**Subject:** San Mateo Park Elementary School HVAC Replacement  
San Mateo - Foster City School District  
Aedis Project No. 2021011.08  
DSA Application #01-120214

### ADDENDUM NO. 1

San Mateo Park Elementary School HVAC Replacement  
San Mateo – Foster City School District  
Aedis Project No. 2021011.08

1 **NEW SINGLE LINE DIAGRAM**  
E4.2 NOT TO SCALE

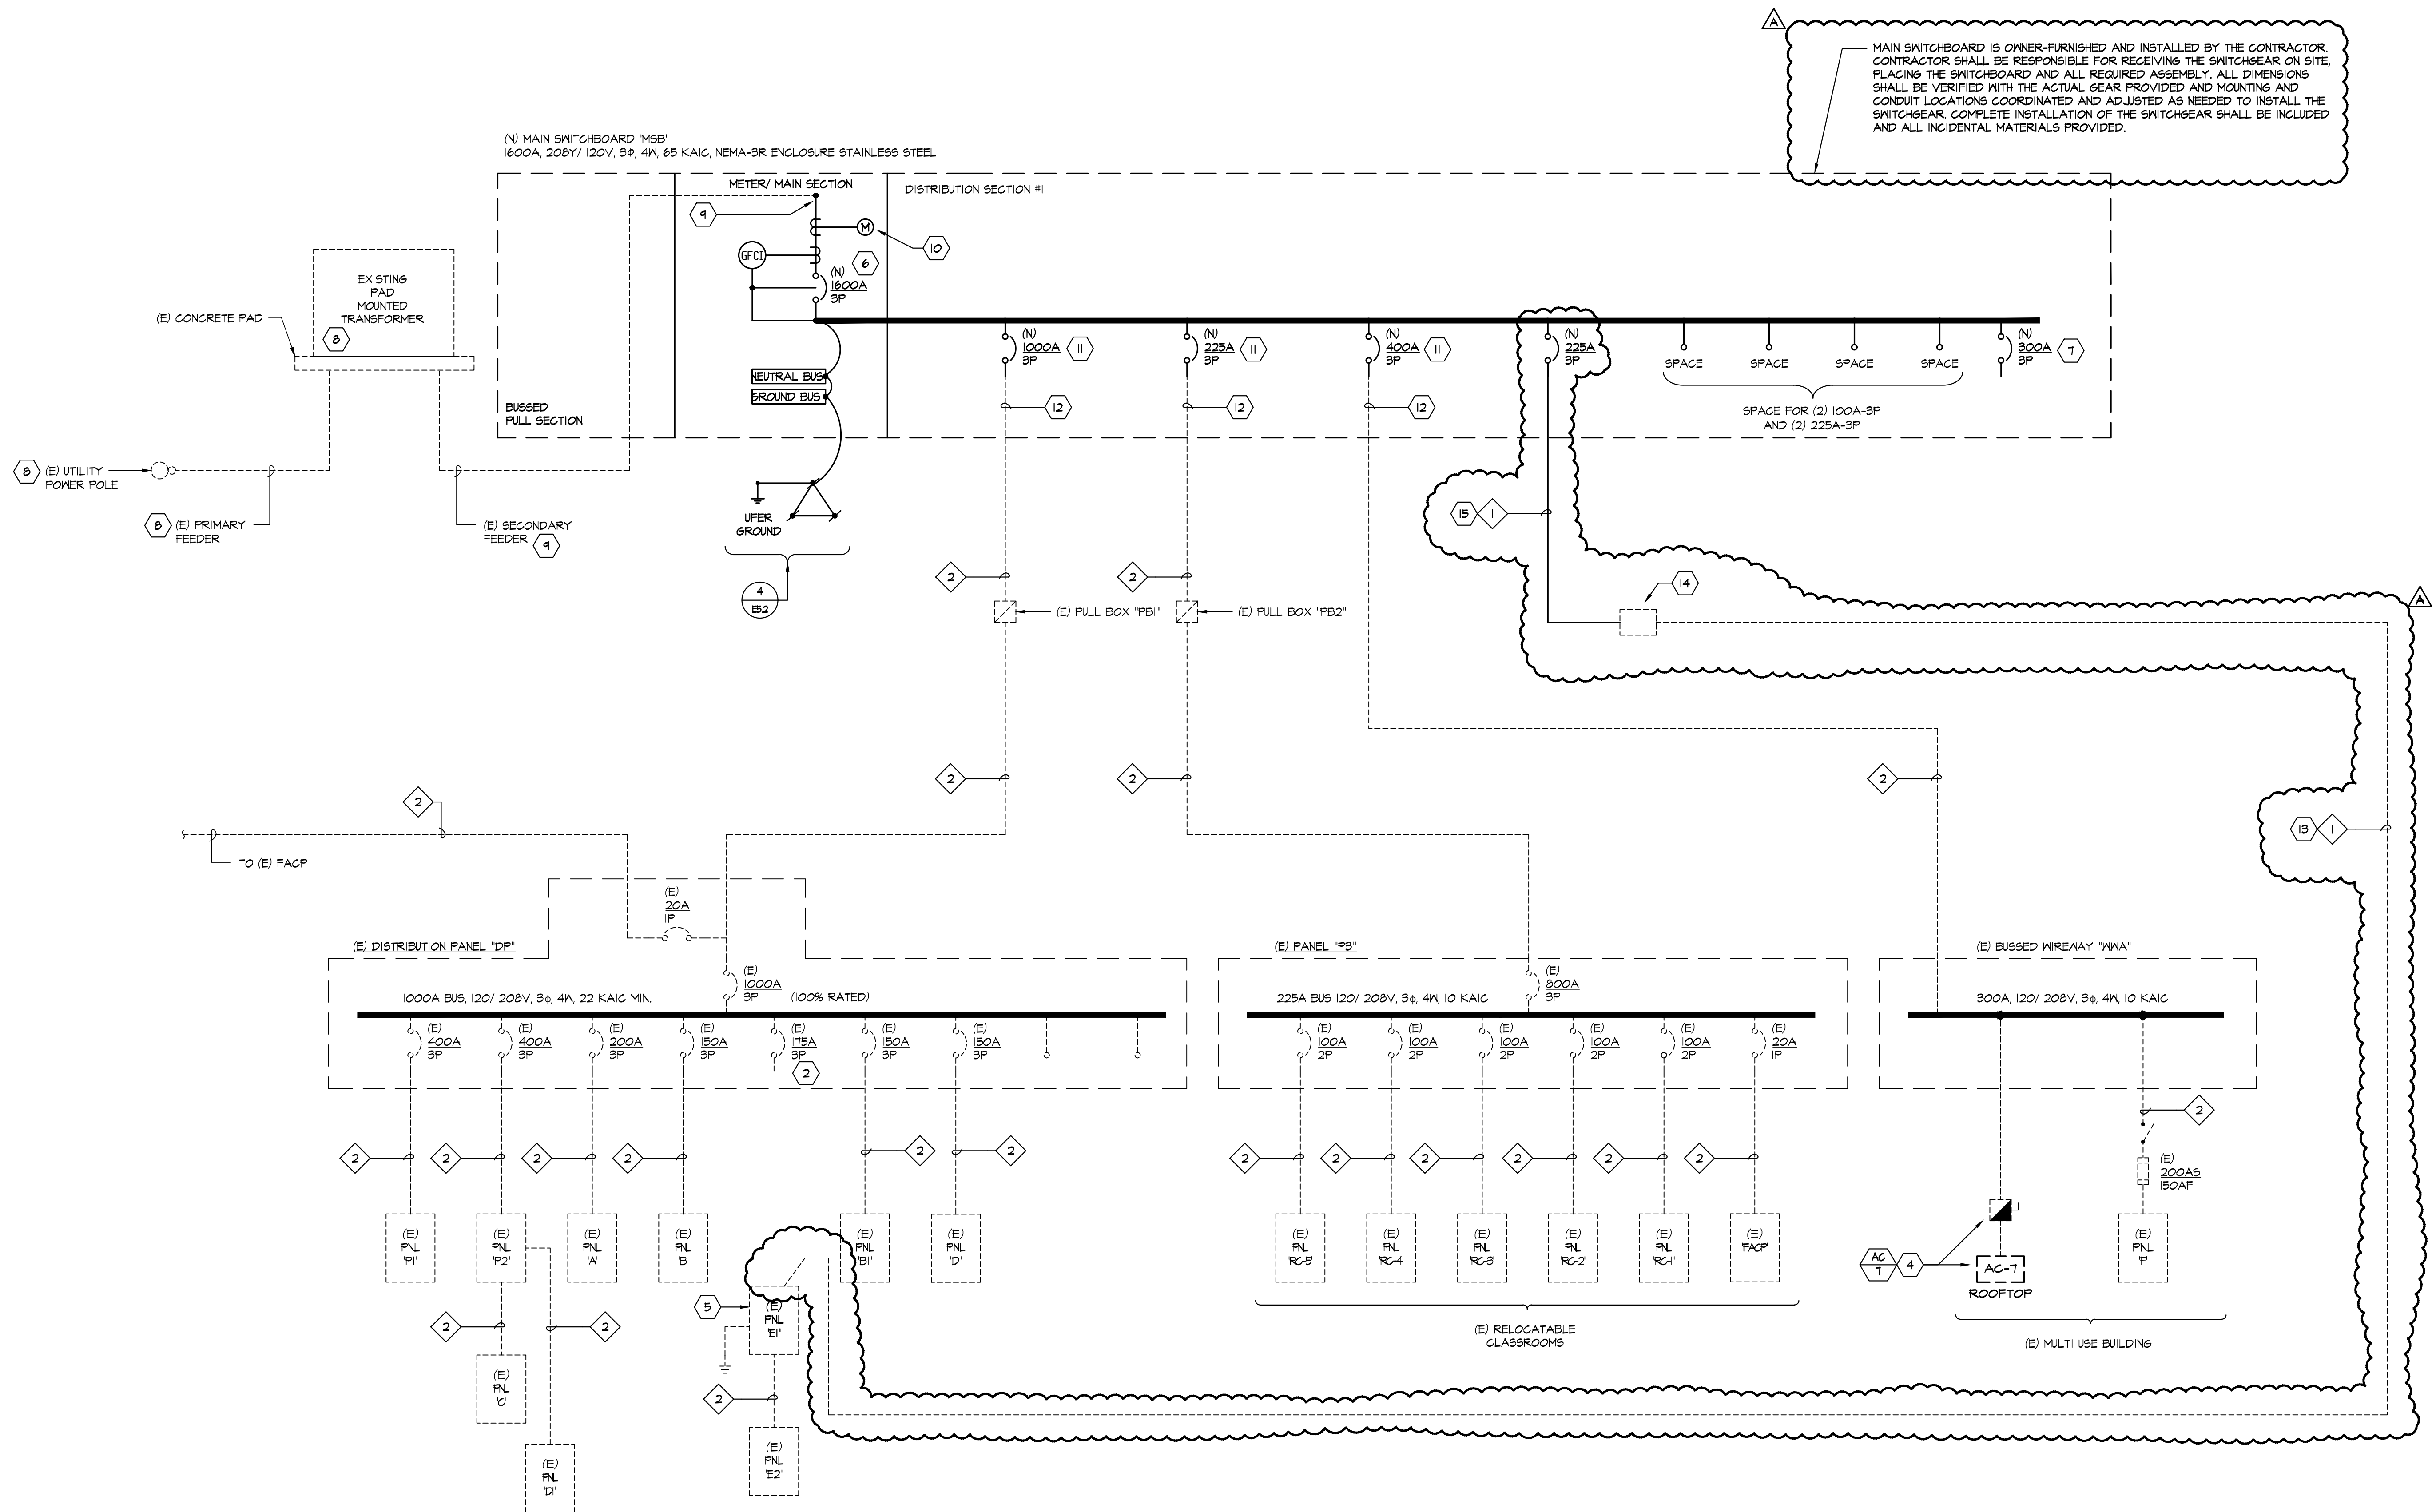
Revise: New Single Line Diagram as shown per AD1-E4.2.

Add: OFCI note in New Single Line Diagram as shown per AD1-E4.2.

Revise: Cable Schedule tag #1 as shown per AD1-E4.2.

Add: Sheet Notes #13, #14 & #15 as shown per AD1-E4.2.
